Groundsmaster® 3500-D

Subject: Rear roller shafts may come loose and rotate in the mount.

Ref: 14-21 Copyright[©], 2001. The Toro Company

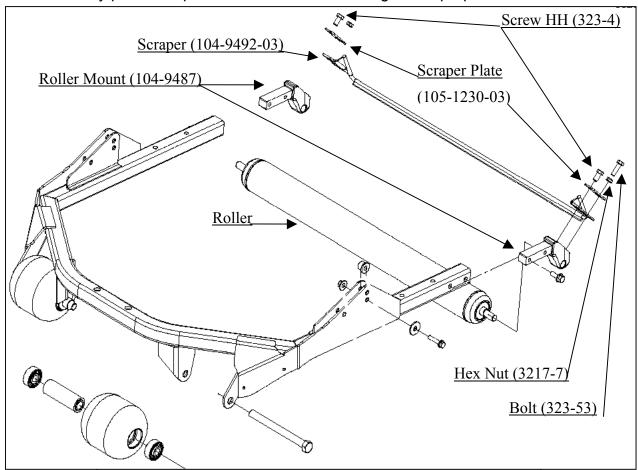
The rear roller shaft may loosen from forces such as impacts from rough terrain and allow the shaft to rotate in the mounts. Roller shafts that have rotated should be repaired using this latest design, which uses a hardened roller shaft with a flat spot for the capscrew to contact and prevent rotation. Roller Service Kit (104-4869) contains the necessary parts to repair one deck. Retain this figure for proper identification.

Roller Service Kit 104-4869		
QTY	Part Number	Description
2	104-9487	Roller Mount
1	105-1227	Roller
1	104-9492-03	Scraper
2	105-1230-03	Scraper Plate
2	323-4	Screw-HH
2	323-53	Bolt
2	3217-7	Hex Nut
